Addendum to the Composite Analysis for the E-Area Vaults and Saltstone Disposal Facilities

WSRC-RP-99-00844-TL

TRANSMITTAL OF THE ADDENDUM TO THE COMPOSITE ANALYSIS

**ADDENDUM TO THE COMPOSITE ANALYSIS FOR THE E-AREA
VAULTS AND SALTSTONE DISPOSAL FACILITIES**

Figure 2.2-1 Simulated Groundwater Divide Before OBG Cap and F- and H-Area PTR Systems; Flow Direction Illustrated by Constant Length Vectors

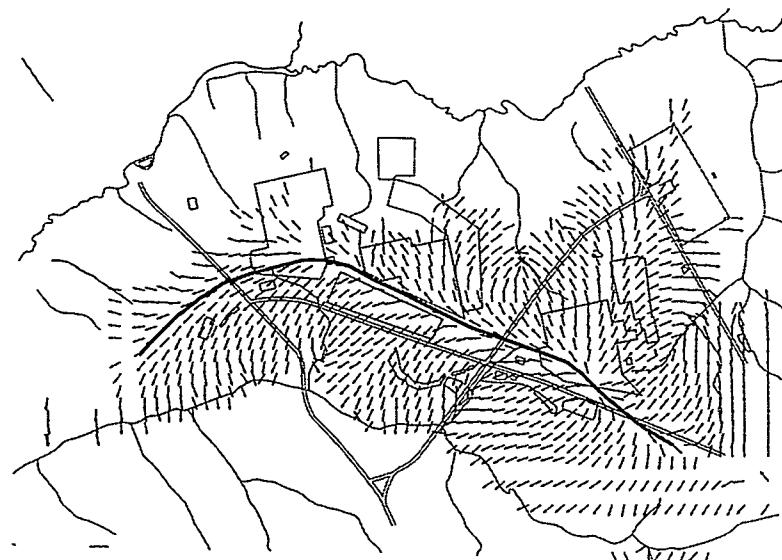
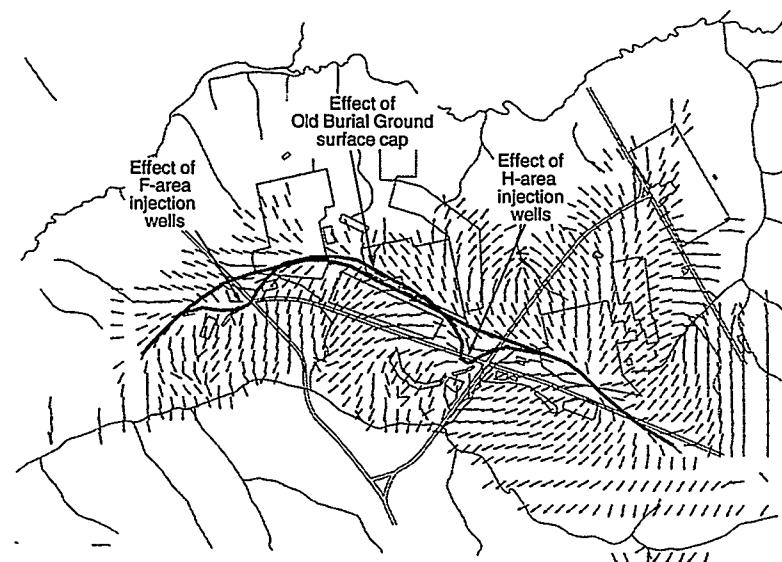
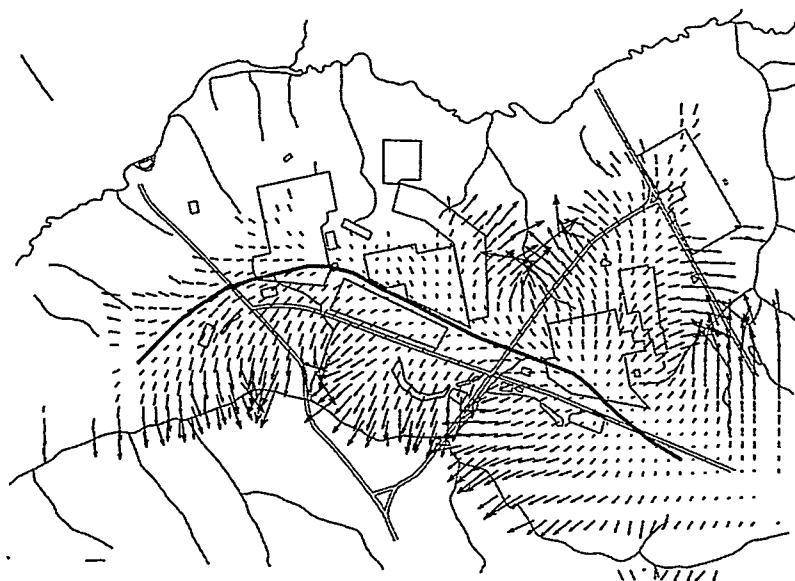
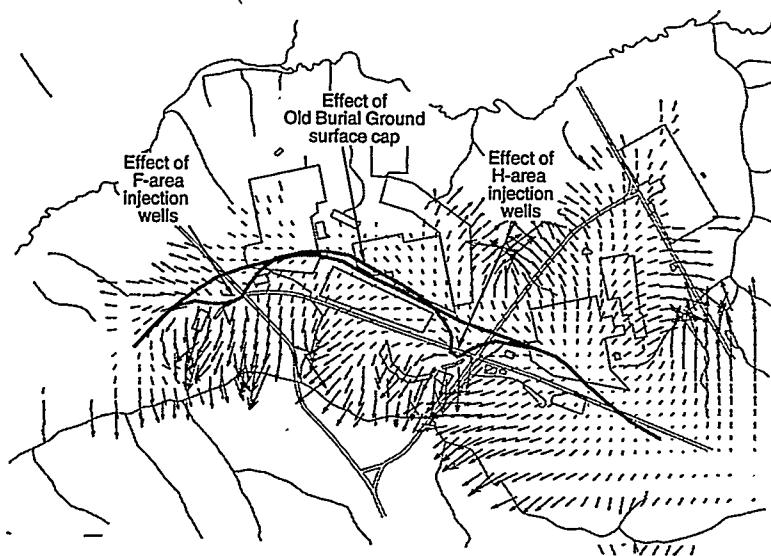
The sensitivity of results calculated in the SRS CA to the location of the groundwater divide was discussed qualitatively in Section 6.4 of the CA. Following is a more quantitative analysis.

In the CA, the present location of the groundwater divide, which lies between the MWMF and the OBG, was assumed to be constant for the entire period of analysis. To illustrate the sensitivity of the analysis results to the location of the divide, doses were estimated assuming that all contaminants released within the GSA would migrate to either of the two surface streams, UTR and FMB.

Figure 2.2-5 Gordon Aquifer Regional Potentiometric Surface

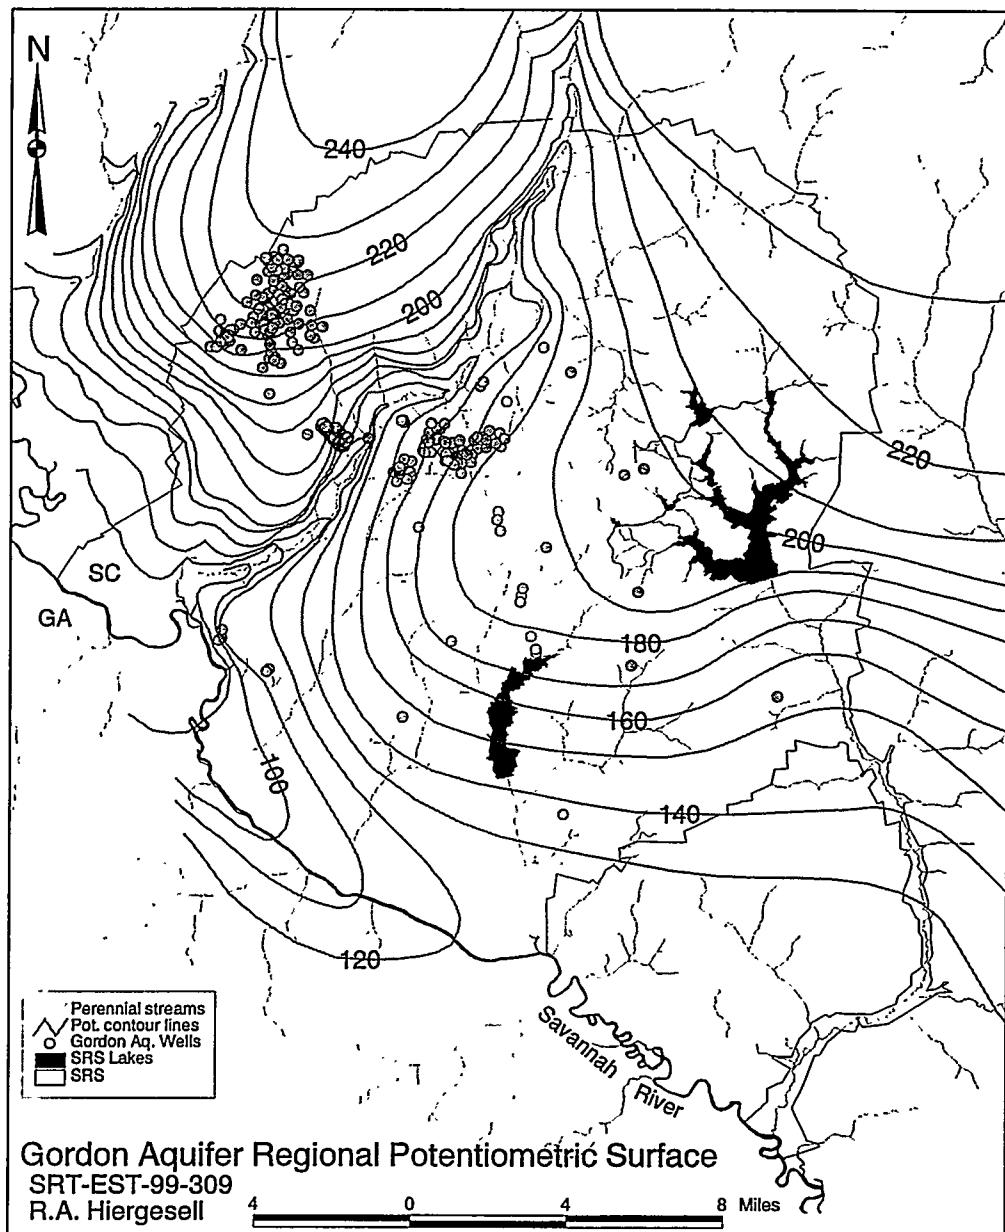
Figure 2.2-5 is a hand-drawn (not produced by computer), large-scale, potentiometric map of the Gordon aquifer that incorporates well and stream water level data with a conceptual understanding of groundwater flow (Hiergesell, 1999). The map includes the up-dip continuation of the Gordon aquifer as the Steed Pond aquifer north of UTR. The Gordon aquifer is recharged from the overlying UTR aquifer, and by lateral flow into the domain across the east and south boundaries of GSA. The Gordon aquifer is discharged by UTR along the north boundary of the GSA and lateral outflow along the west boundary. Relative to recharge and lateral flows, net groundwater flow through the underlying Meyers Branch confining system is small. Simulated groundwater flow in the Gordon aquifer (CA Figure 5.1-20) agrees with Figure 2.2-5 and (CA Figure 5.1-14) which are based on measured water levels.

Figure 2.2-7 General Separations Area Water Table Elevation

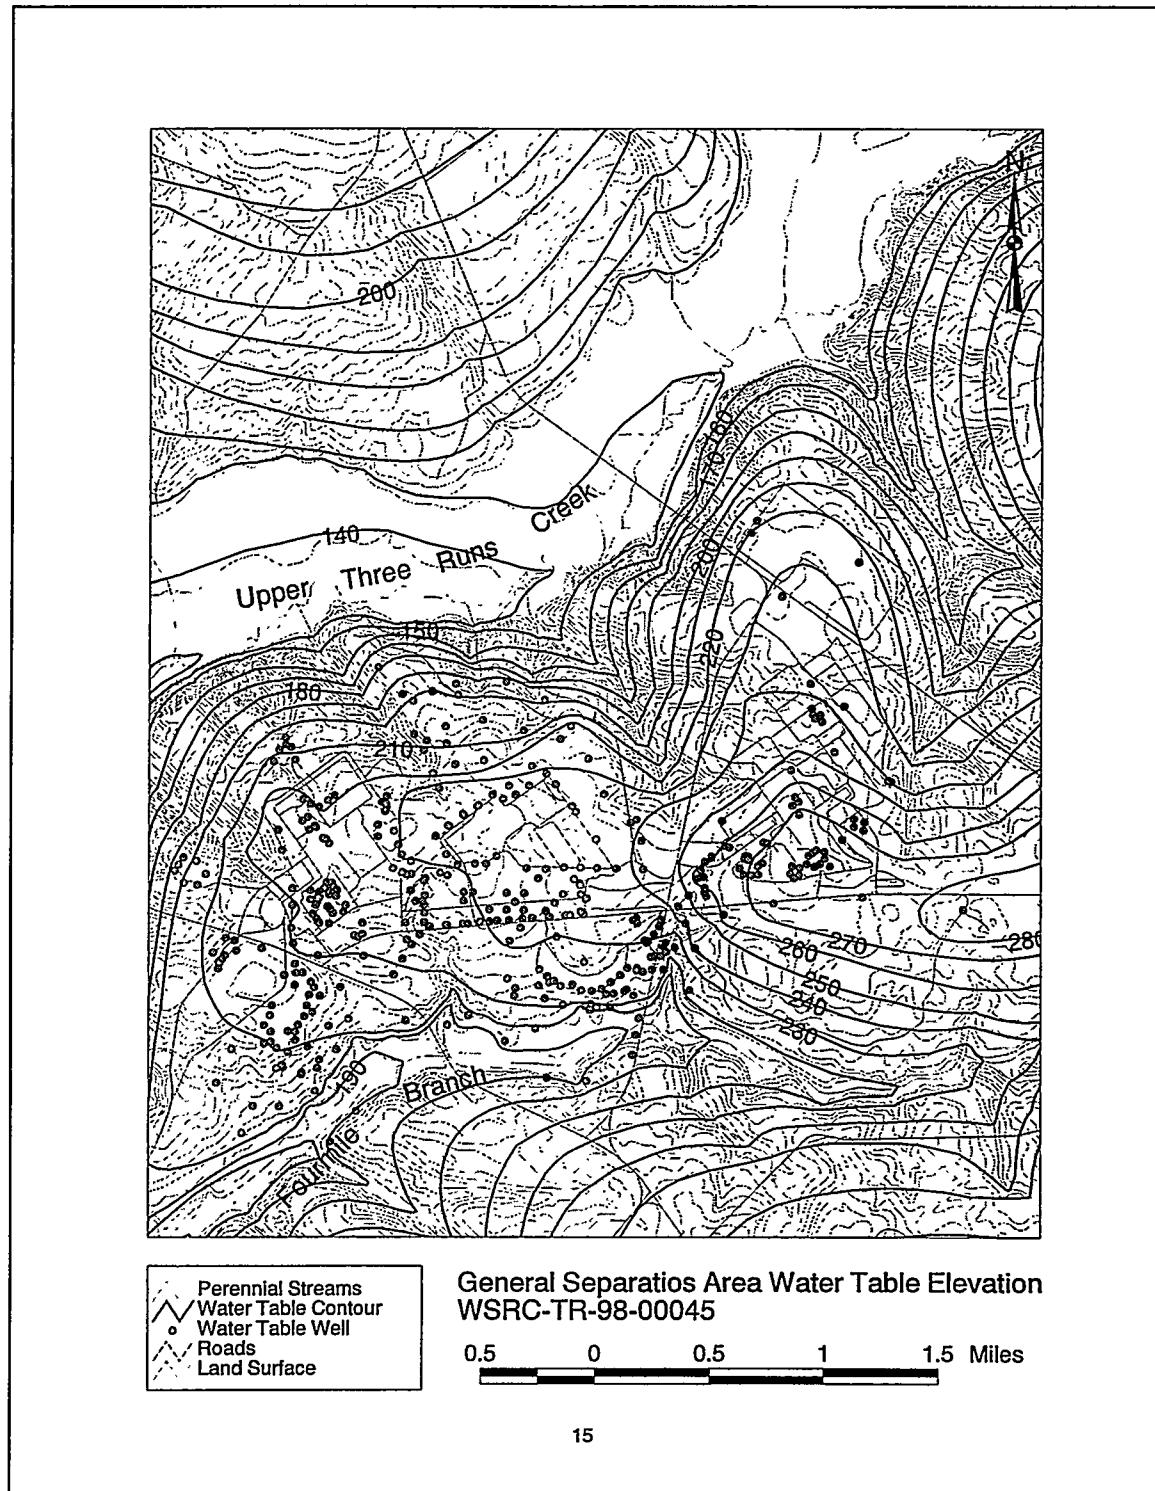
The no-flow boundary between McQueen Branch and FMB can be better justified by referring to Figure 2.2-7, which shows the water table over a larger area than Figure 5.1-13. As shown in Figure 2.2-7, the eastern, no-flow, boundary of the flow model crosses potentiometric lines at nearly right angles. Although there is probably some inward flux across this boundary, the head gradients are very small and can be neglected. Note that the simulated water table (CA Figure 5.1-11) agrees well with Figure 2.2-7, including along the eastern boundary.

Com. No.	Comment	Action
	<p>c) The Upper Three Runs aquifer at the eastern boundary of the model between McQueen Branch and Fourmile Run is defined as a no-flow boundary (figure 5.1-1). The measured head map of Figure 5.1-13 shows that a westward flux into the model domain along this boundary is probable. Note also that the head map uses control data (invented data) to modify head contour lines in this area, potentially masking a larger gradient than shown.</p>	
84	<p>The measured head map of Figure 5.1-13 contains a sharp groundwater mound in Z Area (in the northeast part of the model domain) related to well ZBG 1A. The mound is not simulated by the model (see head map of Figure 5.1-11). The figures are from Flach and Harris (1997), Figures 11 and 36. Neither the CA nor Flach and Harris explain that the mound is the result of one data point, well ZBG 1A, which was omitted from the model as an outlier after completion of the measured head map (Flach and Harris, Appendix E, page 137).</p> <p>In contrast, two other wells with anomalous head data in nearby S Area were omitted from the measured head map (wells SCA 3A and SCA 4A). The head data from all three wells should be treated the same.</p>	See the response to Condition 4.

Figure 2.2-7 is a hand-drawn (not produced by computer), large-scale, potentiometric map of the water table that incorporates well and stream water level data with a conceptual understanding of groundwater flow (Hiergesell, 1998). In the GSA, the water table resides in the UTR aquifer. Alluvial deposits along FMB deeply incise the "lower" aquifer zone of UTR aquifer. FMB is assumed to completely drain the UTR aquifer from each side, such that FMB functions as a groundwater divide as shown in Figure 2.2-7. Drain boundary conditions are specified along FMB for surface nodes while no-flow conditions are prescribed for underlying nodes. Simulated flow agrees with Figure 2.2-7 and CA Figure 5.1-13, which are based on measured water and stream levels.
